Subject: Response to Comments on Workplan entitled "*Supplemental Hawthorn Group Investigation and Monitoring Well Installation Workplan, Koppers Inc. Site, Gainesville, Florida, Revision #3*"

# ATTACHMENT 1 RESPONSE TO COMMENTS

## SUPPLEMENTAL HAWTHORN GROUP INVESTIGATION AND MONITORING WELL INSTALLATION WORKPLAN KOPPERS, INC. SITE GAINESVILLE, FLORIDA REVISION #3

TITLE: Locations of existing and new Hawthorn Group wells

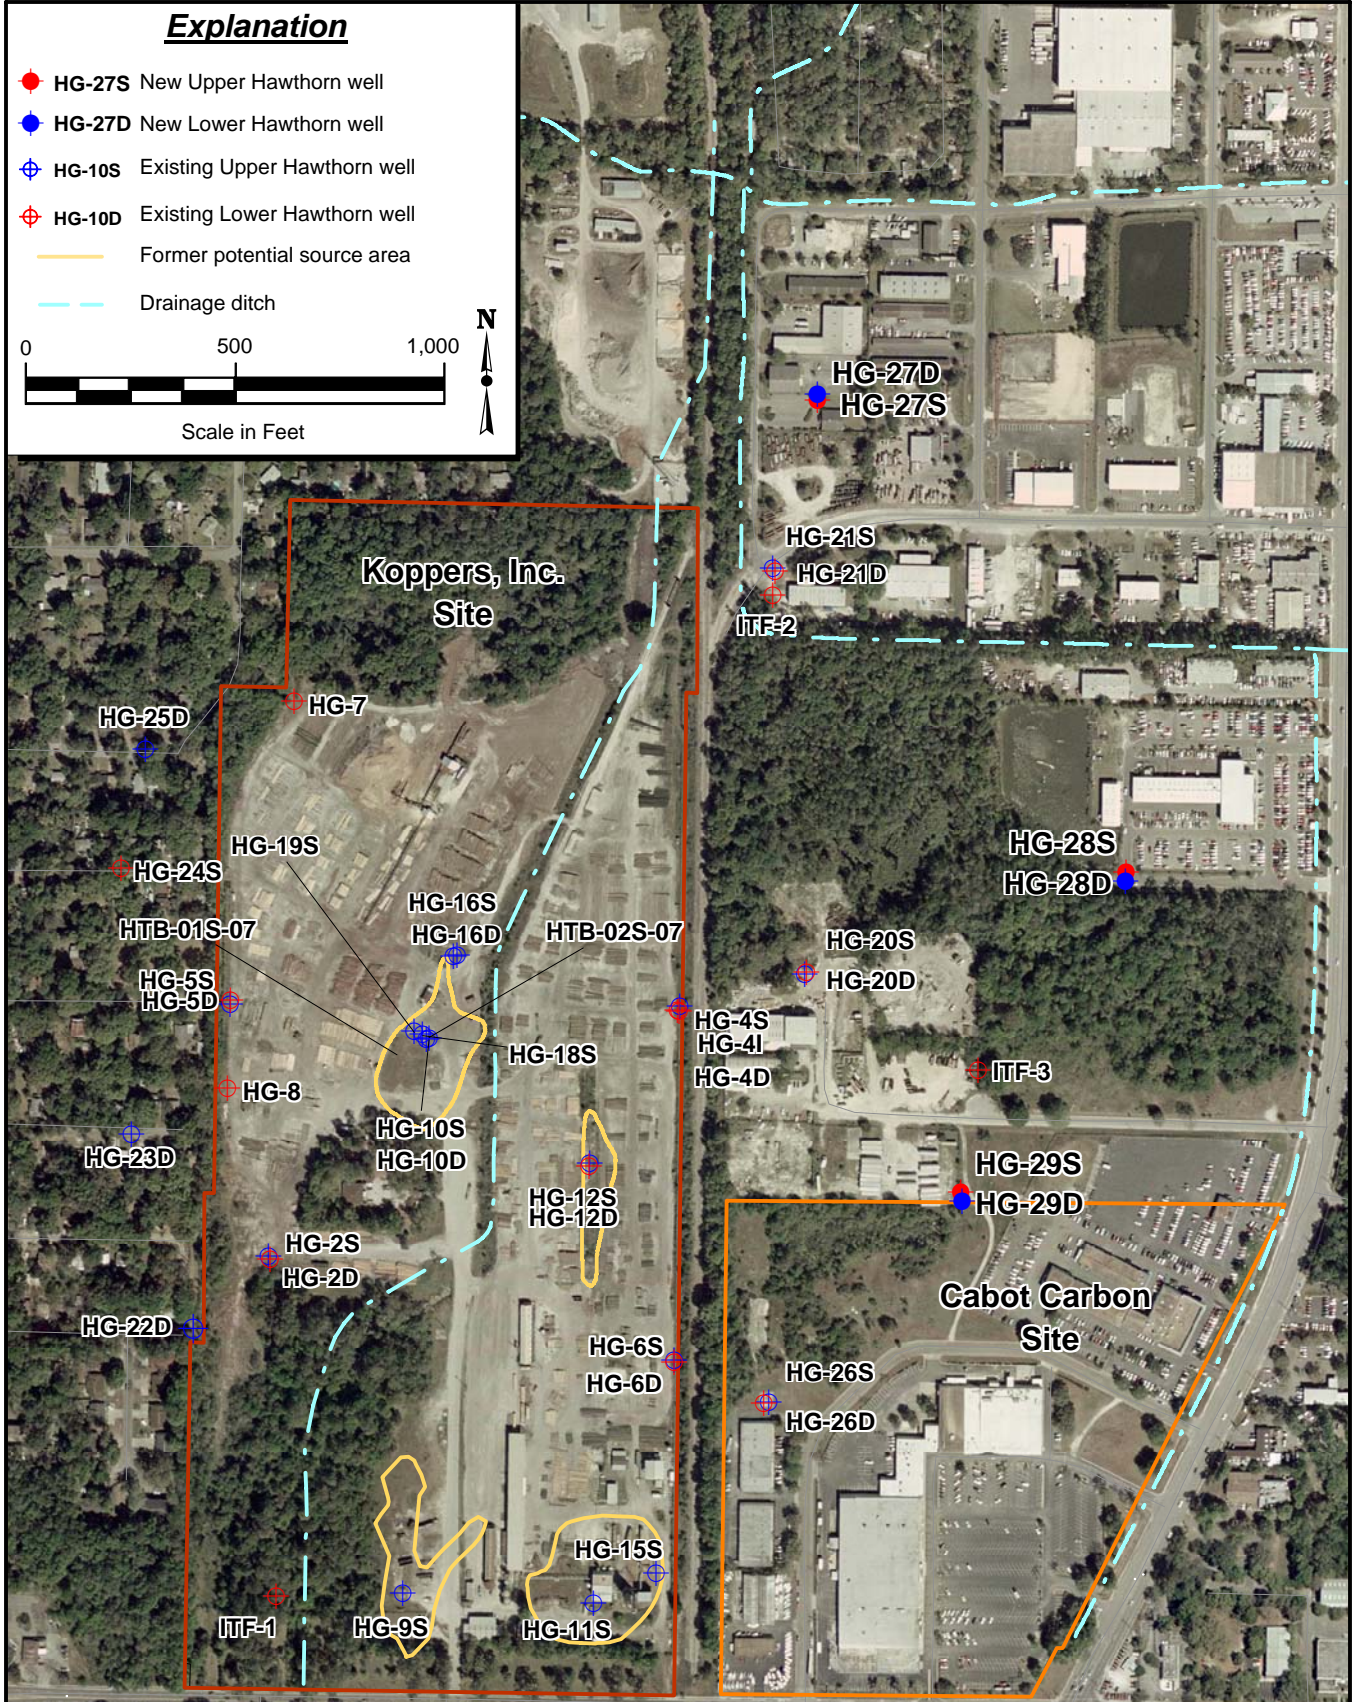
**Comment #1** *“Existing off-property (east of Koppers) Hawthorn monitoring data indicate that at the two existing well pairs closest to the identified principal contaminant source areas on the Koppers property, ground-water contamination is most significant in the upper Hawthorn monitoring zone. Conversely, for the HG-21 well pair near the northern Koppers property boundary, the contamination is more significant in the lower Hawthorn monitoring zone (reference GeoTrans, 2008, Figure 5-1a through Figure 5-3b). Figures in the referenced GeoTrans report indicate that for the upper Hawthorn Group, the direction of ground-water flow in the area east of the Koppers property has a more eastward component than the apparent direction of flow in the lower Hawthorn monitoring zone, at least for the area near the northern Koppers property boundary. With these factors in mind, we recommend shifting, if possible, the location of proposed well pair HG-27 to a location no further from the HG-21 well pair than the distance between HG-21 and the proposed HG-27 location (as shown on Figure 1), but in a direction more northward than eastward away from the HG-21 location. Referring to Figure 1, an ideal location might be in the apparently open area just south or southeast of what appears to be a relatively small, gray-roofed building approximately 900 feet N15° E of the HG-21 well pair.”*

**Comment #2** *“The distance of proposed new Hawthorn wells from the eastern Koppers property boundary should be tied to the contaminant concentrations at existing near-property line and off-property Hawthorn wells. A review of monitoring data shown on Figure 5-1a through Figure 5-3b in the above-referenced GeoTrans report indicates that generally, contamination around the more southern wells (property line HG-6 well pair and off-property HG-26 well pair) is more significant than the contamination in the vicinity of the property line HG-4 well pair and off property well pair HG-20. Given this observation, we suggest that the distance between the HG-28 well pair and the HG-20 well pair be slightly less than the distance between the HG-26 well pair and the proposed HG-29 well pair. The approximate distance between the HG-26 and HG-29 well pairs is 670 feet*

*(based on a review of Figure 1). The distance between the HG-20 and HG-28 well pair is greater, at approximately 850 feet. We recommend that if possible, the HG-28 well pair be shifted southwestward to a location near the margin of the wooded and open areas shown on Figure 1. If this area is unavailable for construction of the new HG-28 well pair (figures included in documents prepared by the contractor for Cabot Carbon indicate there is a stormwater retention pond in the preferred location), then it may still be possible to move the HG-28 location somewhat closer to the HG-21 well pair.”*

**Response:** Beazer is willing to relocate the proposed location for well pair HG-27 further to the north to address concerns expressed in this comment. This comment requests that well pair HG-27 be moved further to the north while maintaining the same approximate distance between the proposed location for HG-27 and HG-21. The distance between HG-21 and the proposed location of HG-27 is approximately 500 feet. Based on the approximately 500 feet distance, well pair HG-27 was moved to a location that is approximately 450 feet N15E of the HG-21 monitoring well pair (see Figure 1).

**Response:** As requested in this comment, Beazer will attempt to relocate the proposed location for well pair HG-28S/D further to the south and closer to well pair HG-20S/D. Field reconnaissance of this area indicates that the new proposed well location for HG-28S/D is the furthest south and west that this well can be located based on current land use (see Figure 1). Physical access issues associated with the undeveloped and forested track of land between well pair HG-20S/D and the proposed location for well pair HG-28S/D prevent the well from being moved further to the west. This location is also constrained by the presence of the retention pond to the northwest of the proposed well pair location.

TITLE: LOCATIONS OF PROPOSED HAWTHORN GROUP INVESTIGATIVE BORINGS

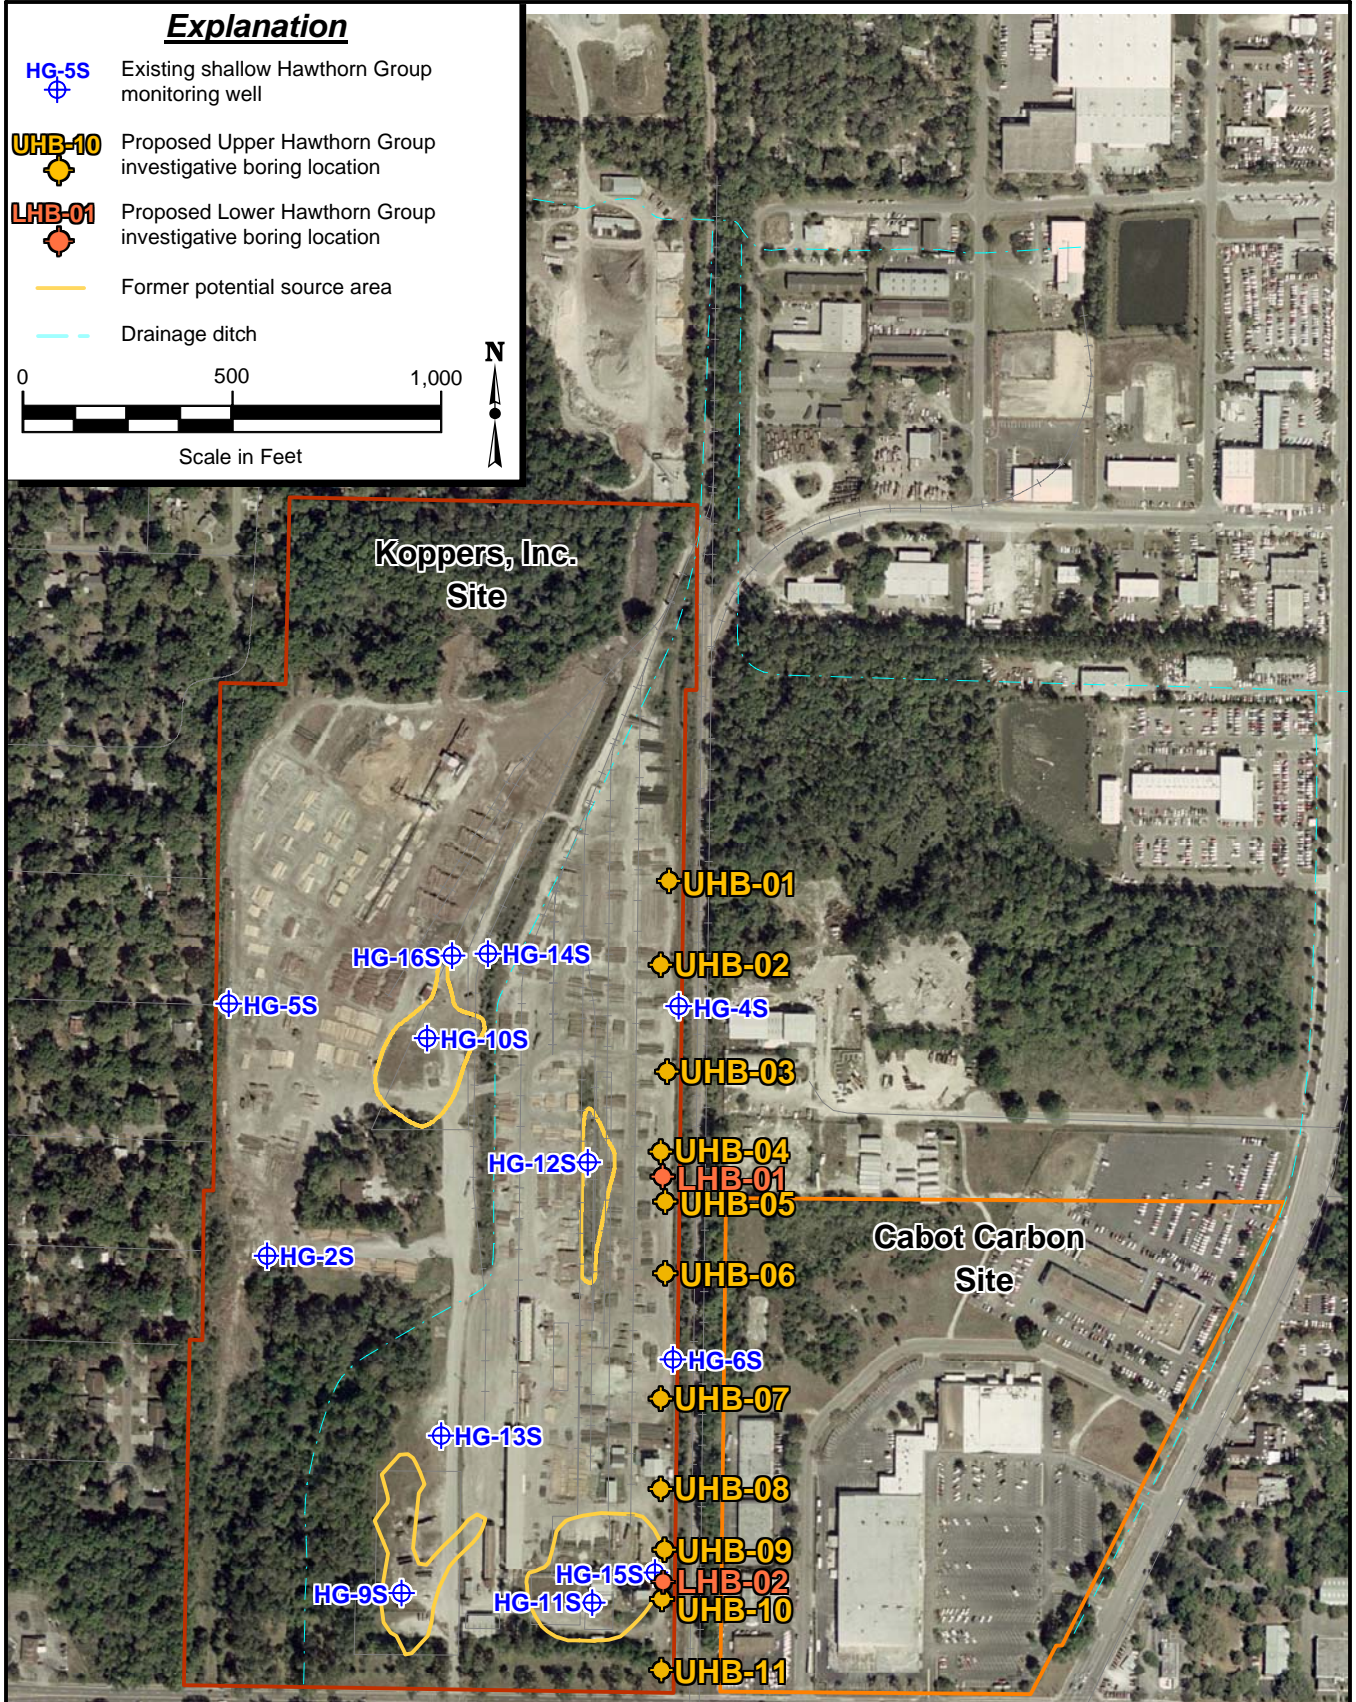
**Comment #6** *“There is shared concern among stakeholders about DNAPL contamination in the lower Hawthorn near the eastern Koppers property boundary. Borings into the lower Hawthorn at locations in close proximity to HG-12D and in close proximity to HG-15S should be undertaken to address this concern.”*

**Response:** The DNAPL boring program along the eastern property boundary was primarily intended to investigate the potential for lateral DNAPL migration in the Upper Hawthorn. Borings installed into the Lower Hawthorn will necessitate the use of an isolation casing completed into the HG middle clay unit. In response to this comment, Beazer proposes the installation of two additional Lower Hawthorn borings along the eastern property boundary (see Figure 2). The workplan will be revised to address the installation of these borings.
